# **PRELIMINARY HYDROLOGY FOR RENO CANNON INTERNATIONAL AIRPORT**

**NOVEMBER 19, 1992**

**RENO CANNON INTERNATIONAL AIRPORT  
RECONSTRUCT & EXTEND RUNWAY 16L-34R  
CONSTRUCT SERVICE ROAD & DRAINAGE**

**Preliminary Hydrologic Study  
From  
Thirty Percent Design Submittal**

**Exhibit 3.6**

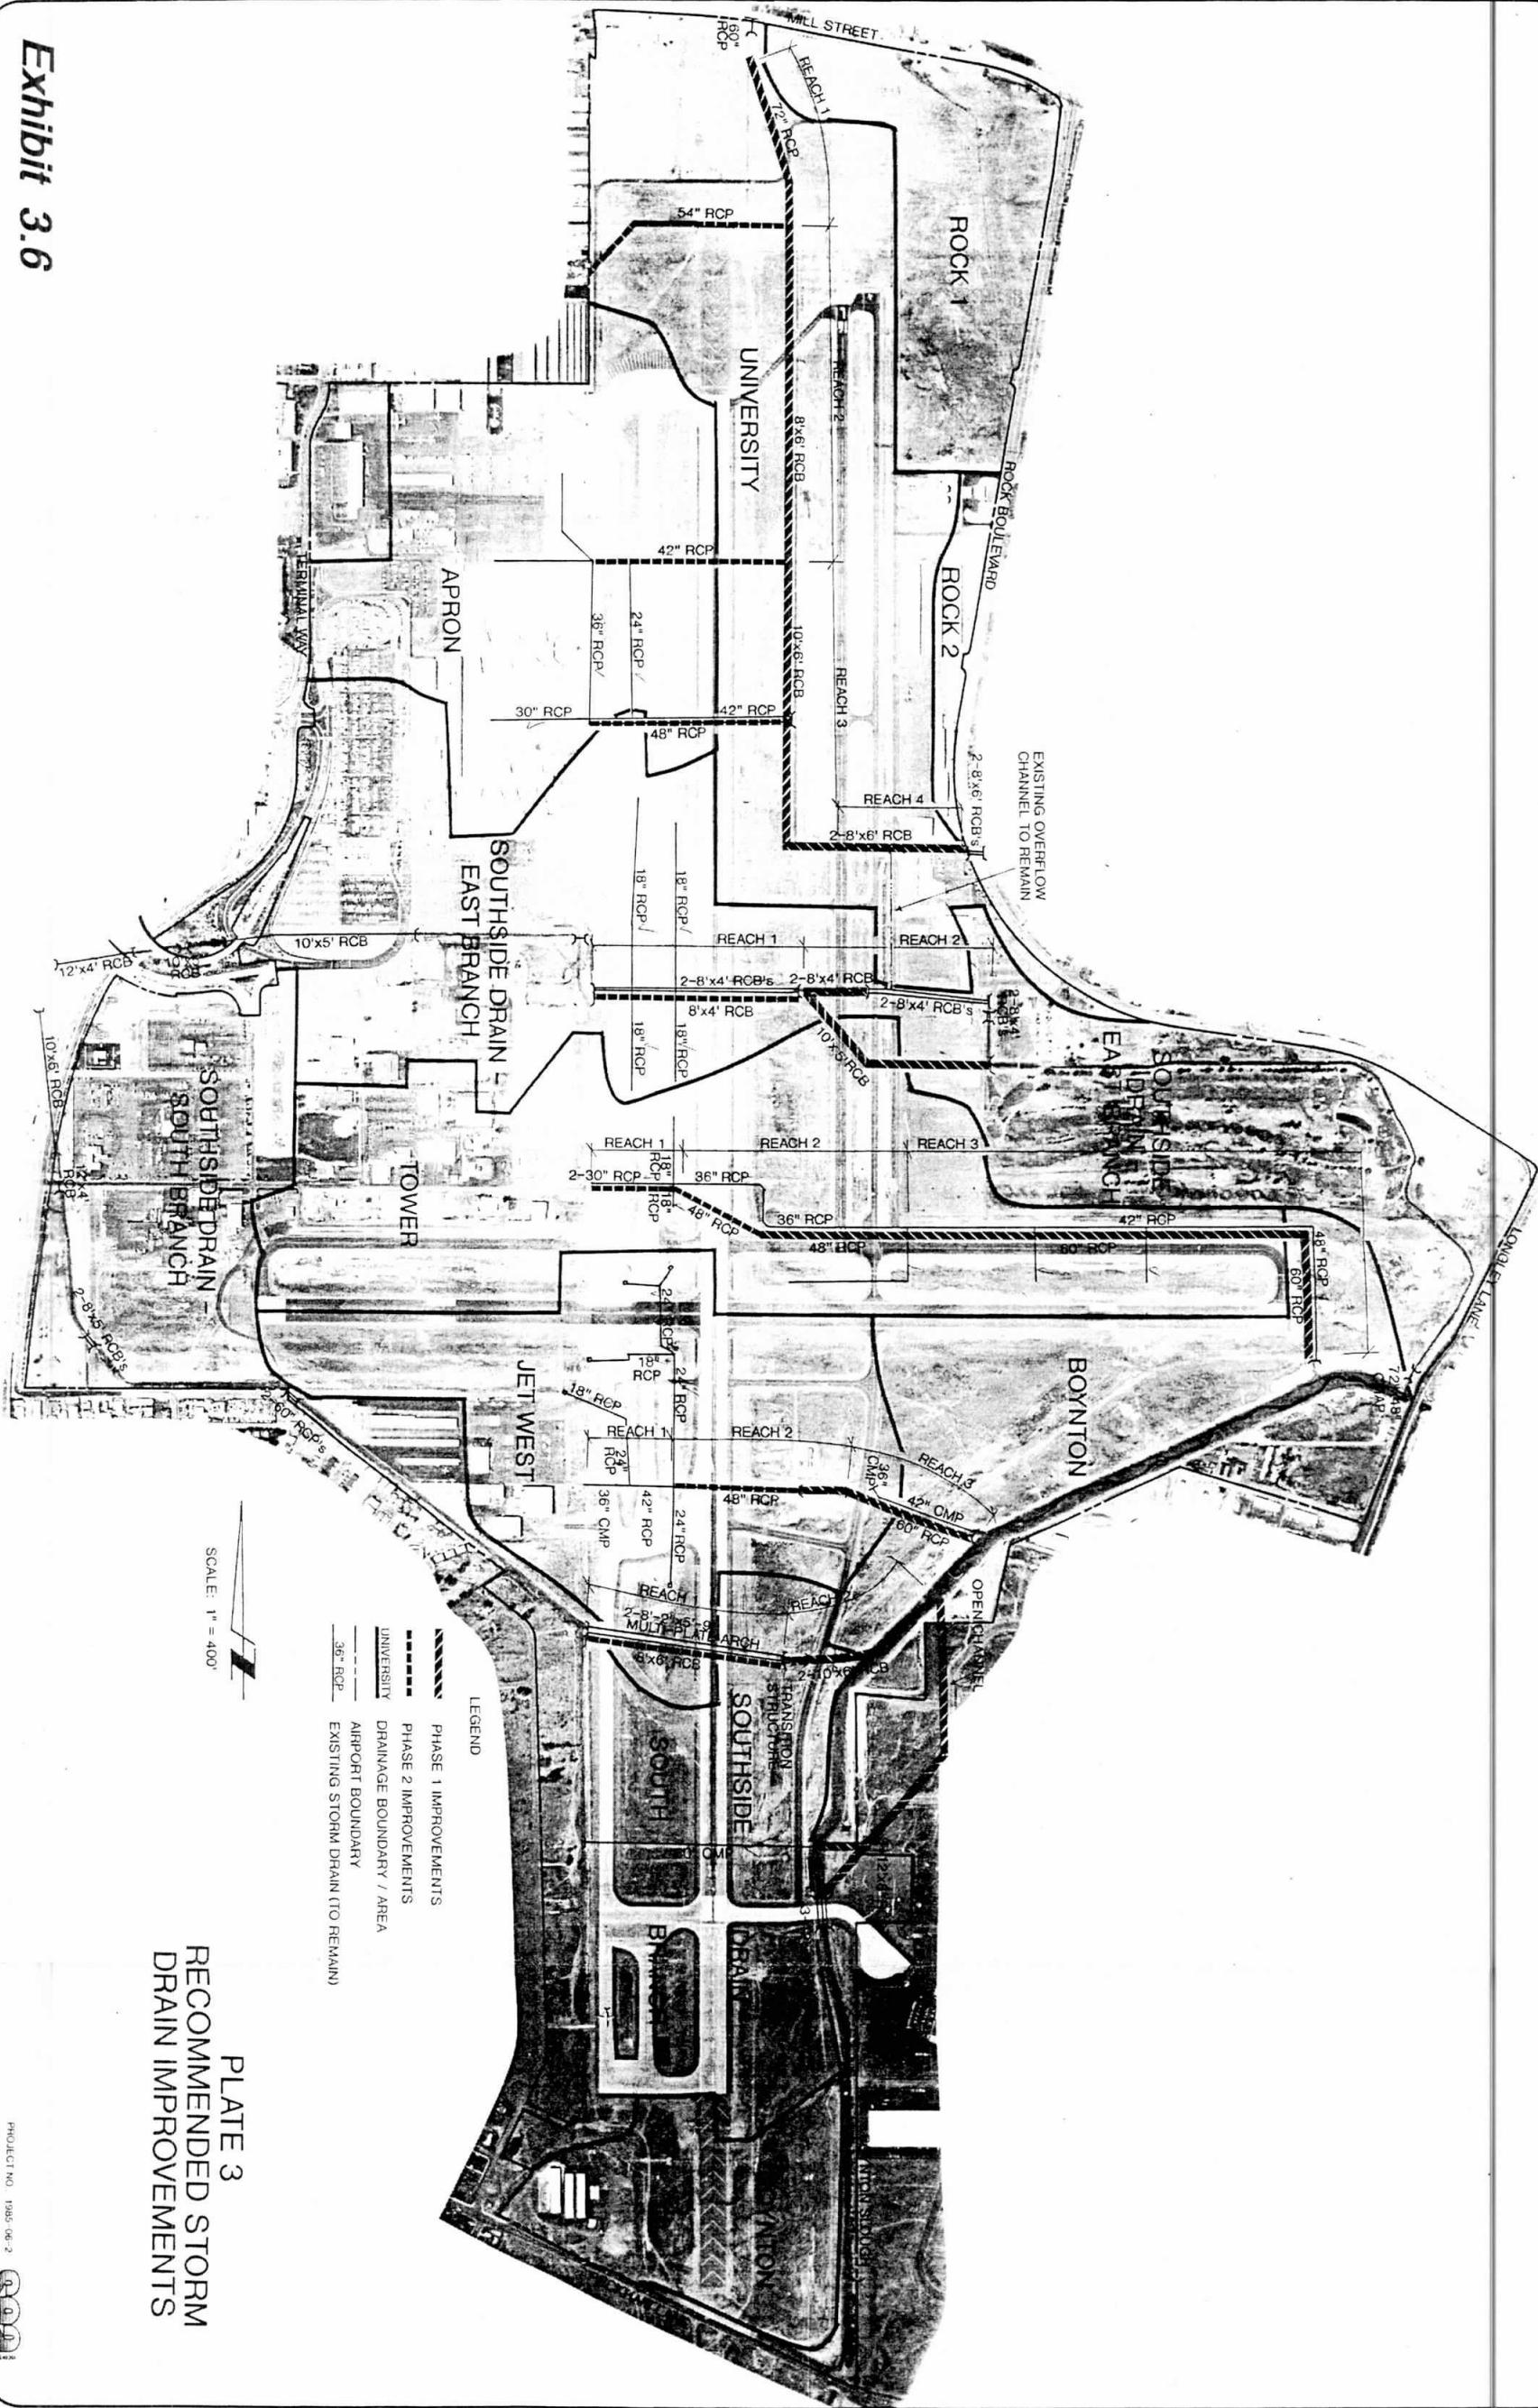
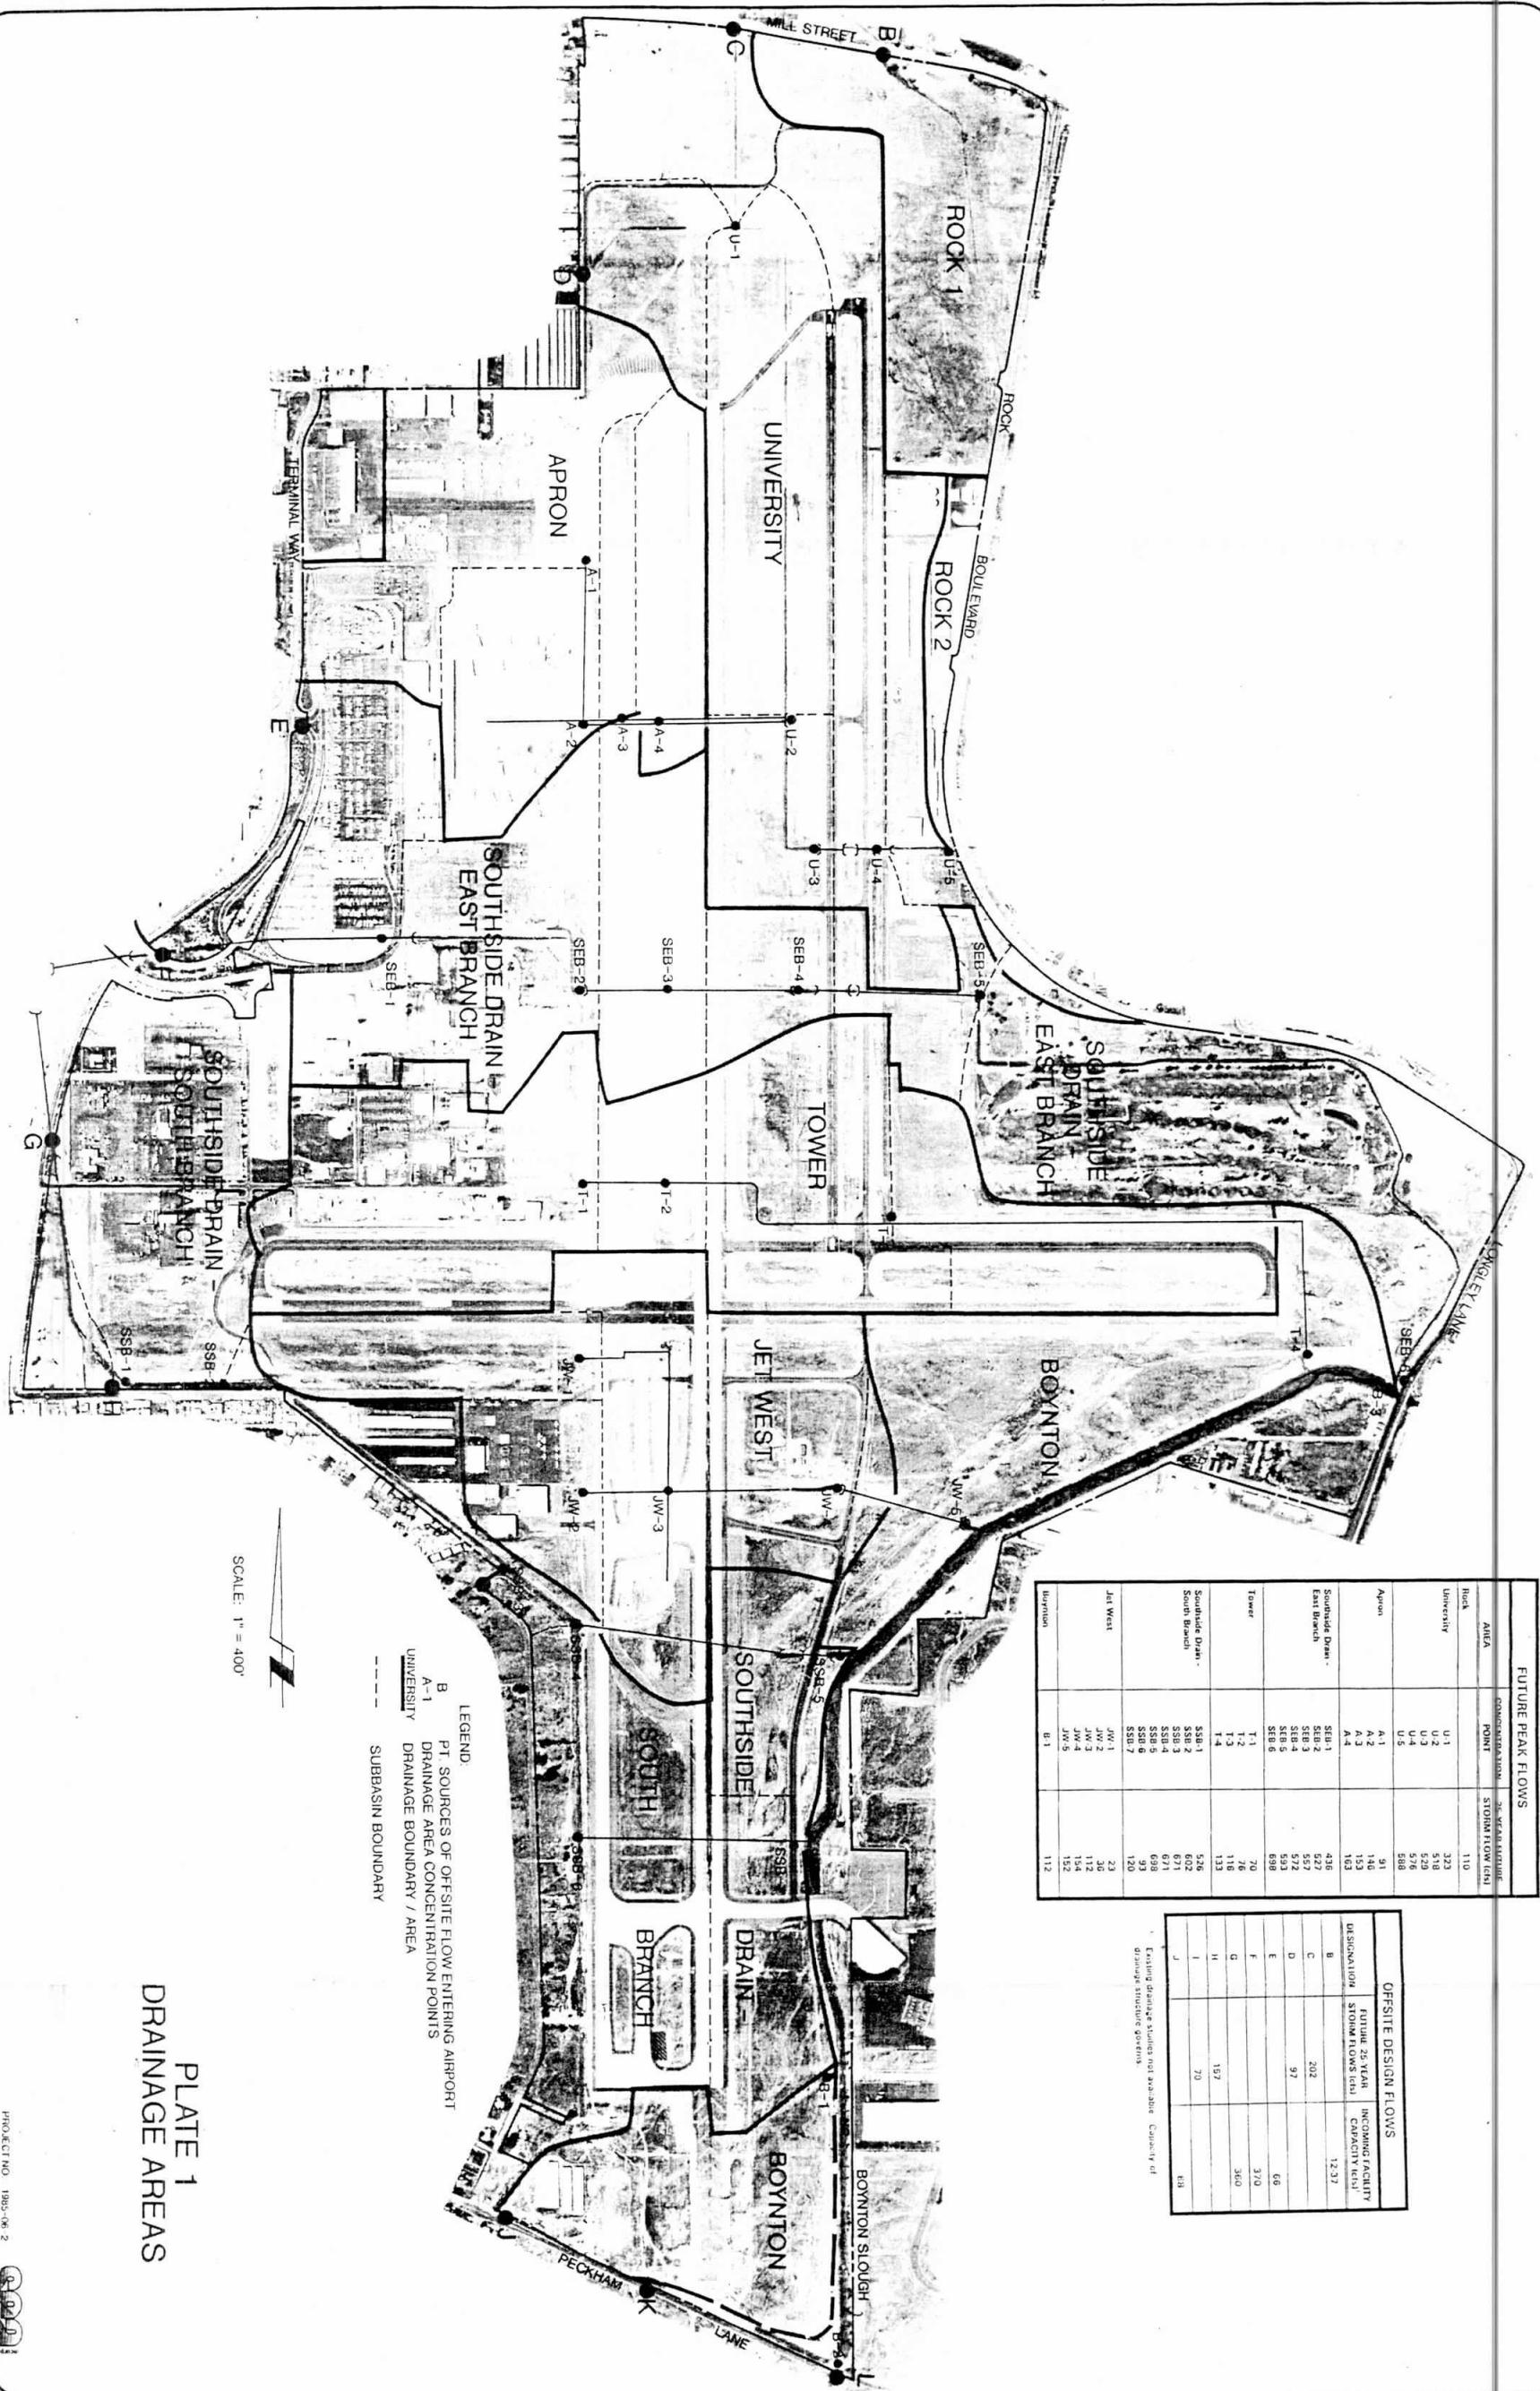
- ▶ Tailwater and target upstream headwater determination based on existing conditions
- ▶ Evaluation of the hydraulic design recommended in the Master Plan Drainage Study performed by SEA, Inc (refer to Exhibits 3.4 through 3.6).
- ▶ Analysis and design of alternative drainage systems
- ▶ Recommended hydraulic design
